SUNDRY NOTICES AND REPORTS ON WELLS

7. If Unit or CA, Agreement Designation
Querecho Plains Bone Spring Unit
8. Well Name and No.
QPBSSU 13-2
9. API Well No.
30-025-29679
10. Field and Pool, or Exploratory Area
Querecho Plains Bone Spring
11. County or Parish, State
Lea, NM

Querecho Plains Bone Spring Sand Uni
Well 13-2 - Revision 1

Re: Completion Procedure - Revision 1
QPBSSU 13-2
Lea County, NM

Schematic for the

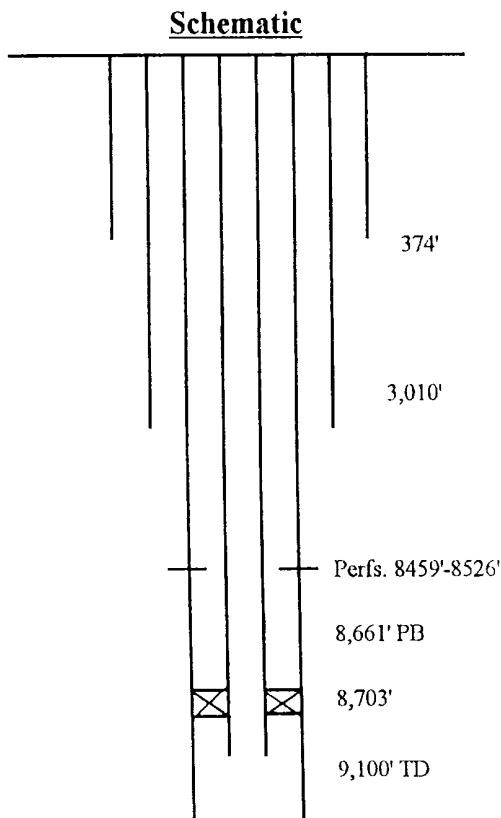
The collapse of the 5½" casing at 2020', plus the confirmed leak in the same area, emphasizes the need to leave the 5½" casing as it is and not try to remove or repair the casing due to its poor mechanical condition. The cementing of tubing to make a tubingless completion is by far the best alternative.

The attached recommended procedure plus the wellbore schematic shows the placement of the tubing and cement. The placement of cement has been discussed in detail. First, there is 13⅝" casing set at 374'. Should there be any fresh water in the area, it typically is no deeper than 200'. The fresh water sand is protected. Next 8⅝" casing is set to 3010' with cement circulated to the surface. The 5½" casing has good cement to 4350'. The proposed procedure provides cementing the 2⅞" x 5½" annulus to within 100' of the top of the Unitized Formation to the surface. The 5½" x 8⅝" annulus will be cemented from area of leakage, 2020'-2038' to surface. The surface sands will be protected by four strings of steel pipe (1.538") and 7.5" of cement. This is considered adequate to protect any surface areas. Measurement of displacement fluid is extremely critical to assure leaving no cement in the tubing or below the tubing, and still maintain cement no higher than 100' above the Unitized Formation.

Circulate cement in 5 1/2" x 8 5/8" annulus from 2038' to surface

2 7/8" EUE 8rd, J-55, 6.5#/ft
internally coated w/ Duolene
fiberglass. Top joint &
10 bottom jts externally coated
w/epoxy.

Circulate cement in 2 7/8" x 5 1/2" annulus from approximately 8262' to surface.

Bottom of Cement Approx 8262'
Bottom of Tubing - 8350'

Cap with 10' 100 mesh sand
